FOUNDATION INVESTIGATION REPORT  
FOR  
RANKIN LAKE SERVICE ROAD UNDERPASS  
W.P. 290-97-00, SITE 44-384  
HIGHWAY 69, DISTRICT 52  
HUNTSVILLE, ONTARIO

W.P. 290-97-00, Site 44-384

FOUNDATION DESIGN REPORT  
FOR  
RANKIN LAKE SERVICE ROAD UNDERPASS  
W.P. 290-97-00, SITE 44-384  
HIGHWAY 69, DISTRICT 52  
HUNTSVILLE, ONTARIO

We have conceptually reviewed the Foundation reports and the Technical Review Package for the above projects produced by Peto MacCallum Ltd. Consulting Engineers for McCormick Rankin Corporation to evaluate the performance of the Consultant. Since, we were given a very short time to review, we have not reviewed the report in detail. The accuracy of the subsurface information and the technical recommendations remain the responsibility of the consultant. Following are our comments:

DRAWN J.S.	DATE APRIL 1998	SCALE AS SHOWN	JOB NO. 97TF088A	DRAWING NO. 1
---------------	--------------------	-------------------	---------------------	------------------

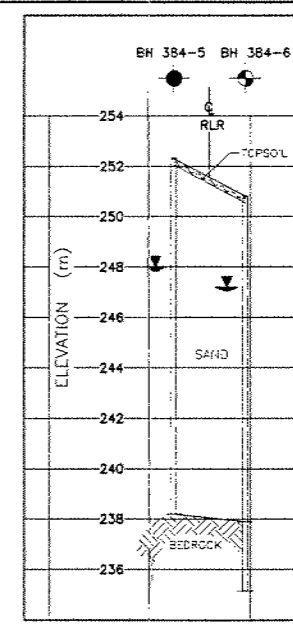
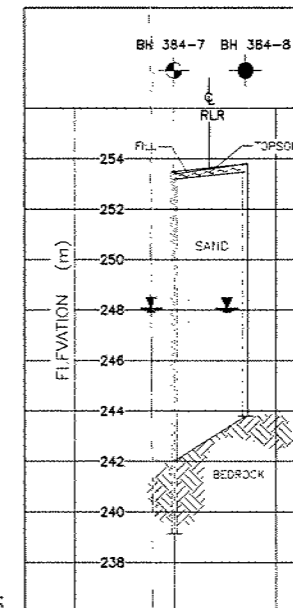
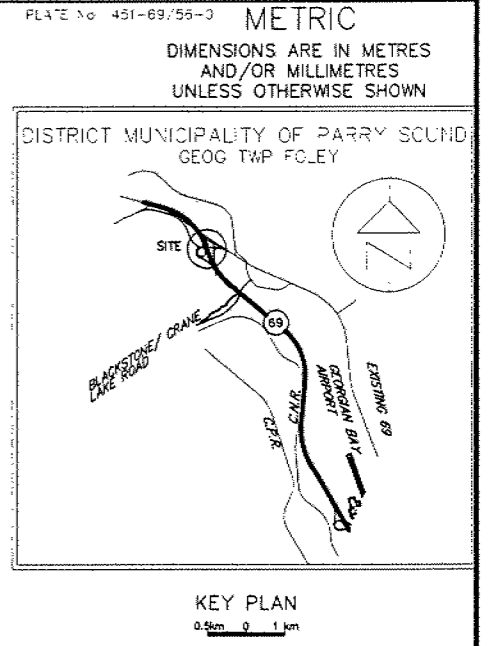
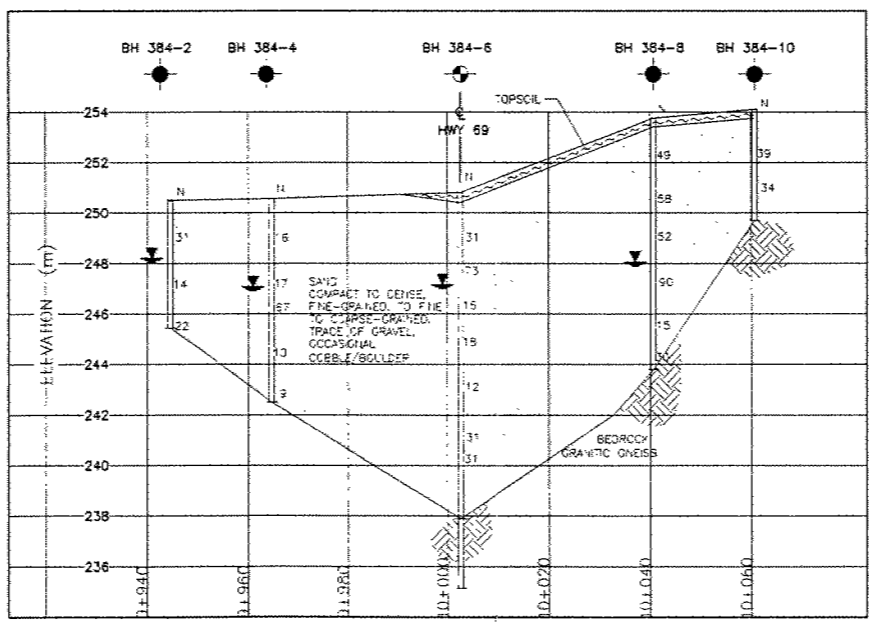
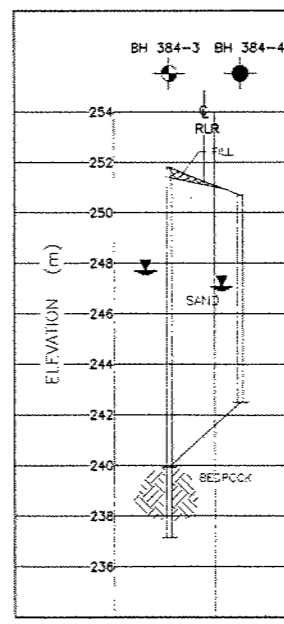
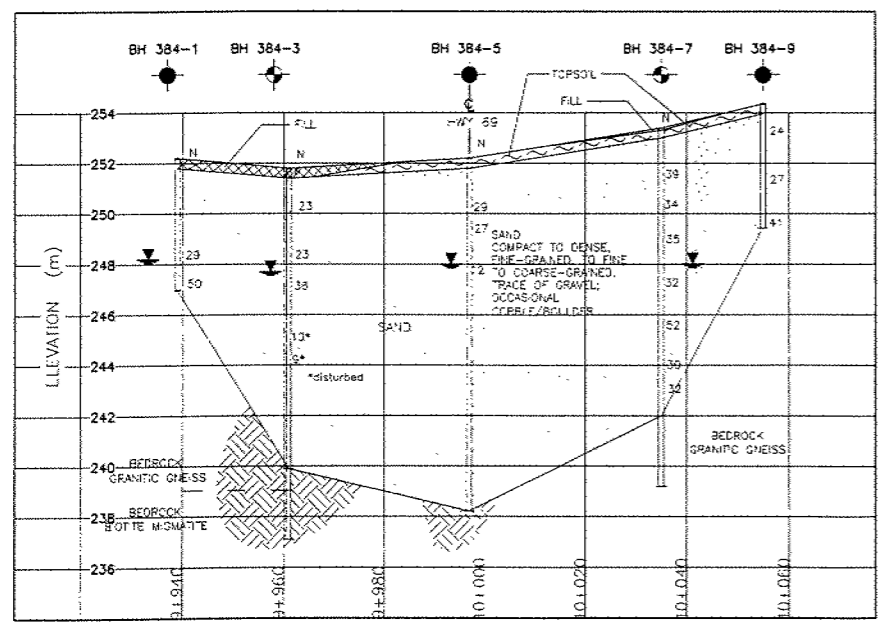
Drawing No. 1, dated April 1998

- Existing Hwy 169 should be shown on the Key Plan.
- Proposed foundation location should be shown on the plan.
- A large scale profile with a proposed grade of Hwy 169 should be provided.

- N-values and soil description should be provided on the cross sections and profiles.
- The cross sections are very small. When the drawing will be reduced to half size for the contract package, then it would not be legible. The cross sections should be produced in large scale. There is enough room on the drawing to draw cross sections in large scale.
